**TOWN OF MOUNTAIN VILLAGE
REGULAR DESIGN REVIEW BOARD MEETING
THURSDAY AUGUST 1, 2019 10:00 AM
2nd FLOOR CONFERENCE ROOM, MOUNTAIN VILLAGE TOWN HALL
455 MOUNTAIN VILLAGE BLVD, MOUNTAIN VILLAGE, COLORADO
REVISED AGENDA**

3.	10:05	45	Miller	Public Hearing Quasi-Judicial	Consideration of a Design Review: Initial Architecture and Site Review Application for a new single-family residence on Lot 640BR 1, Timberview (continued from July 11, 2019)

4.	10:50	45	Miller	Public Hearing Quasi-Judicial	Consideration of a Design Review: Initial Architecture and Site Review Application for a new single-family residence on Lot 640BR-4, Timberview

SITE PLAN/ROOF PLAN
SCALE: 1" = 5'

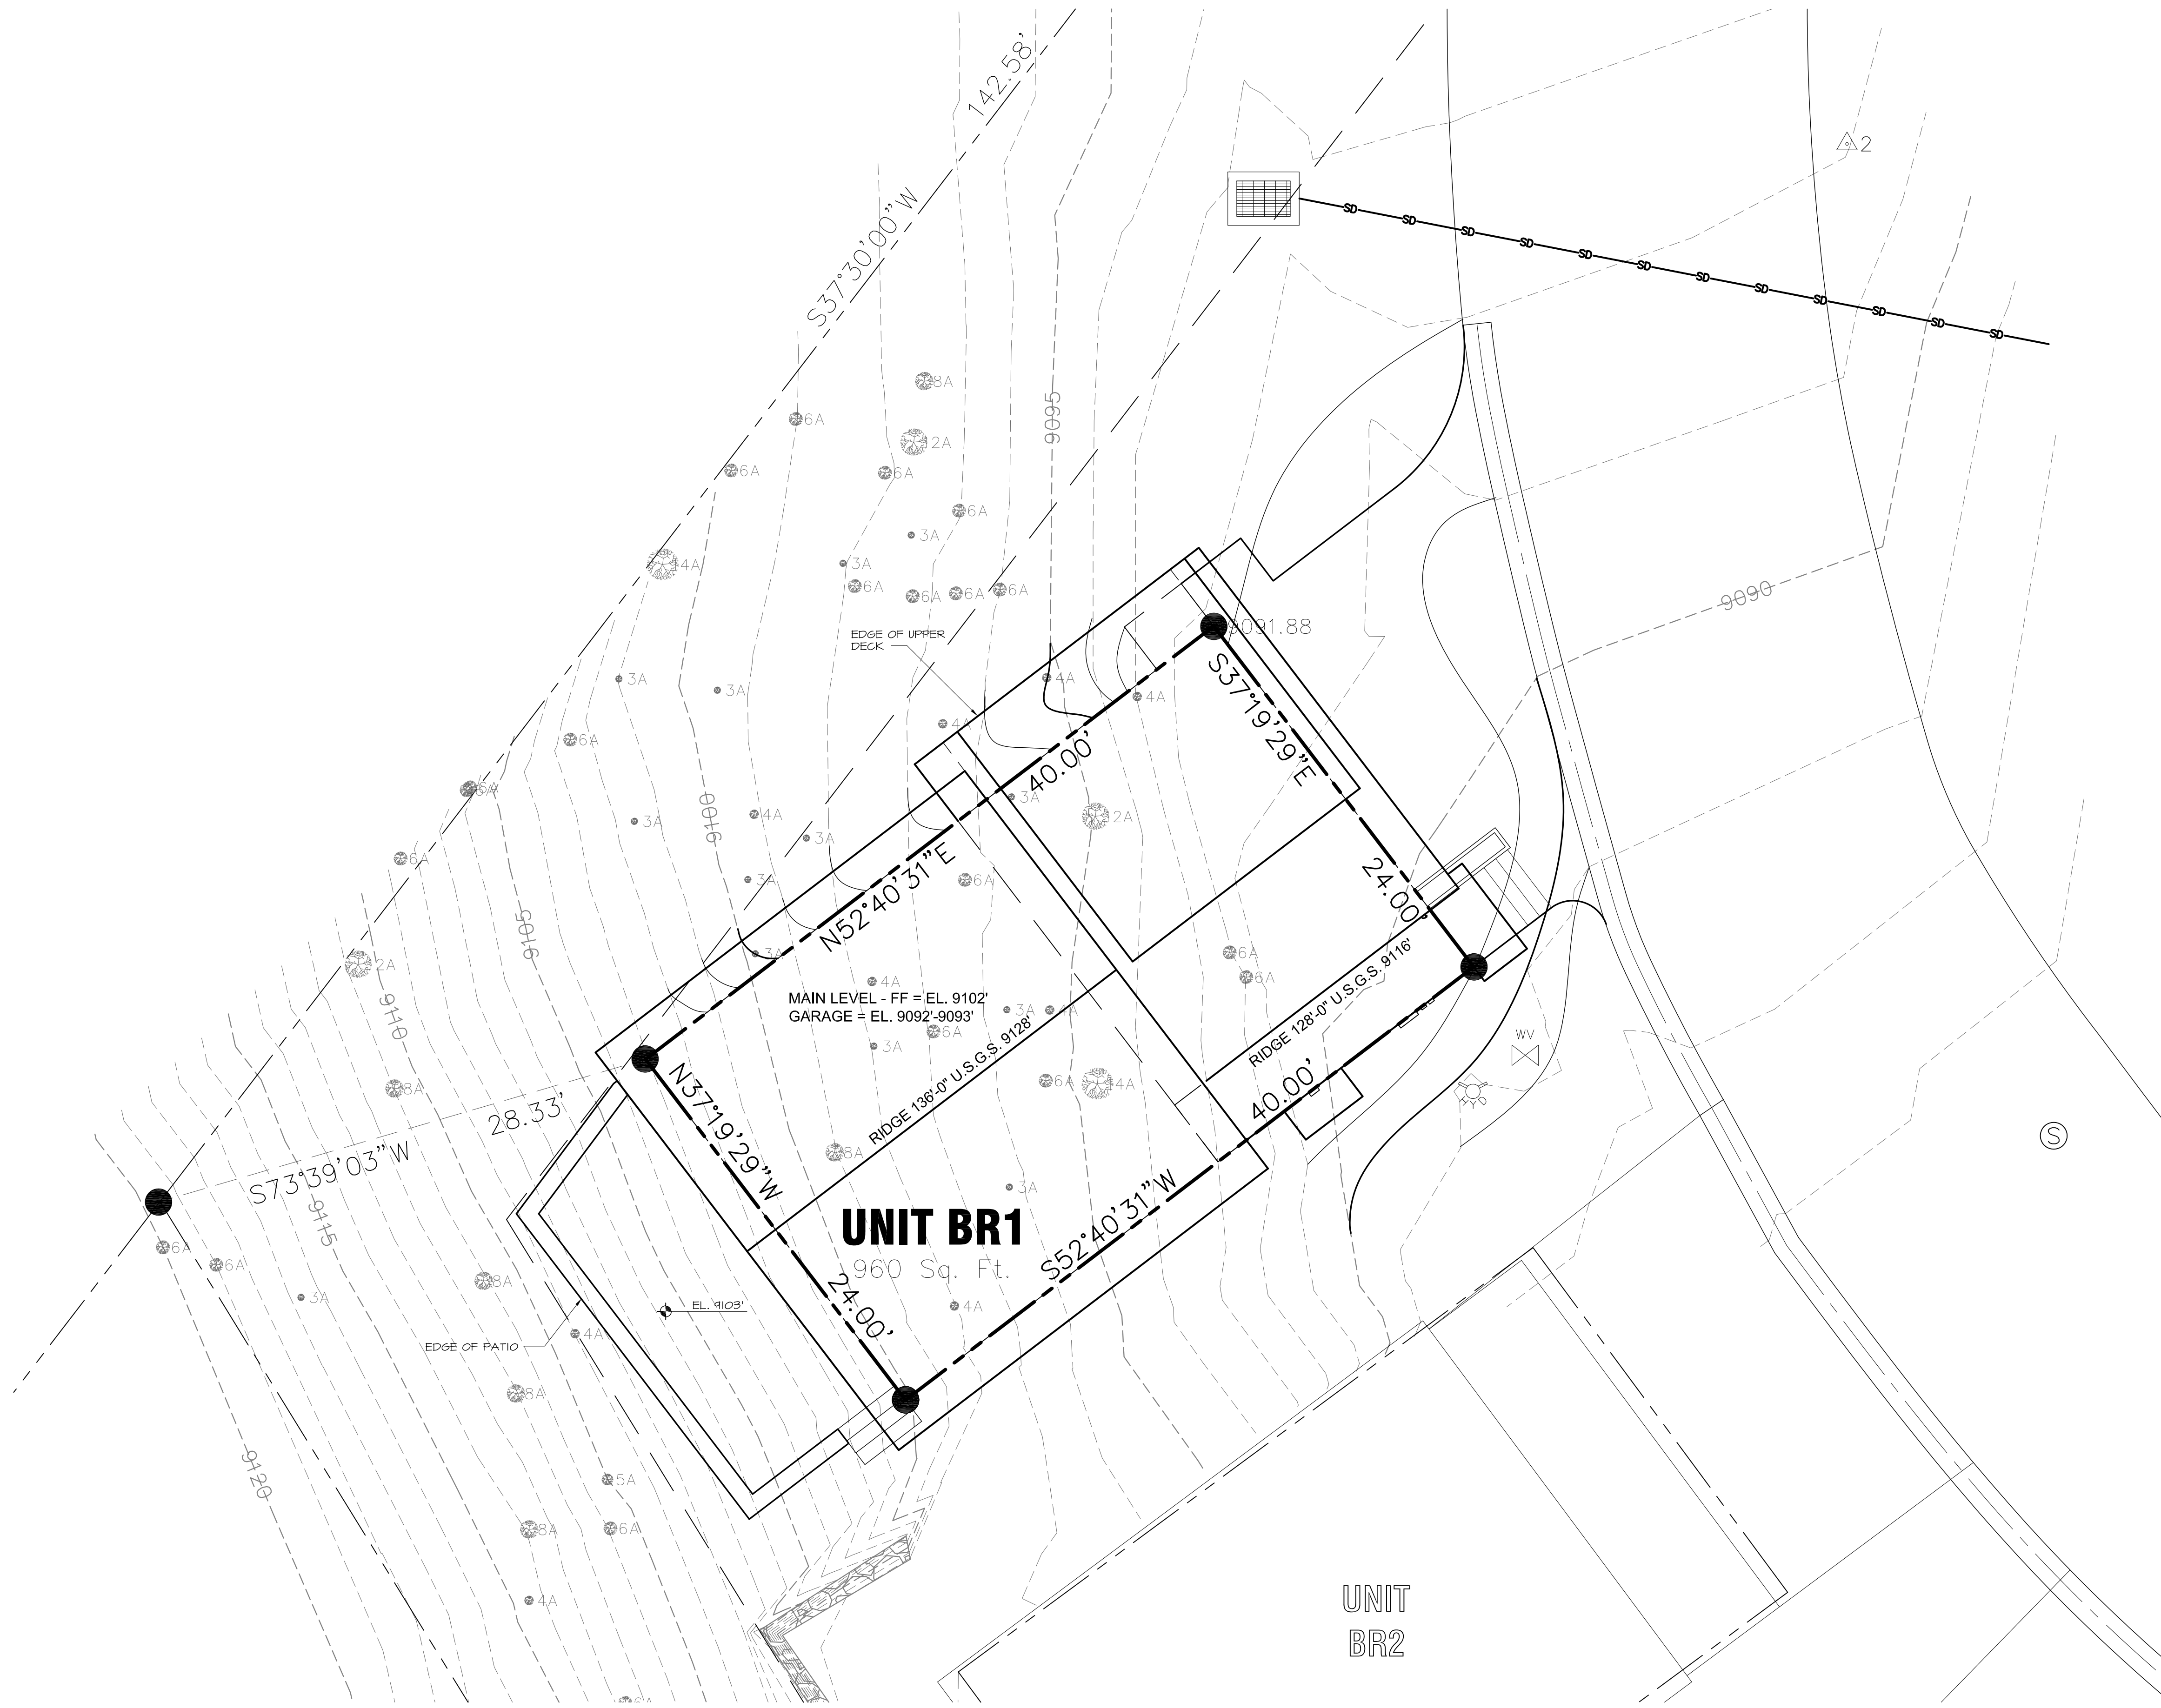
The CDC provides that the GE and other setbacks be maintained in a natural, undisturbed state to provide buffering to surrounding land uses. The CDC does provide for some development activity within the GE and setbacks such as Ski Access, Utilities, Address Monuments, and Fire Mitigation. All encroachments not listed above will require encroachment agreements between the property owner and the Town.

Note: Since the July 11, 2019 DRB meeting, the applicant has revised their plans to remove the patio / hot tub encroachments as requested by the DRB.

- 1) Prior to submittal of Final Architectural and Site Review, the applicant shall revise the plan set and remove all encroachments from the General Easement unless they are deemed appropriate and acceptable improvements by the Design Review Board.
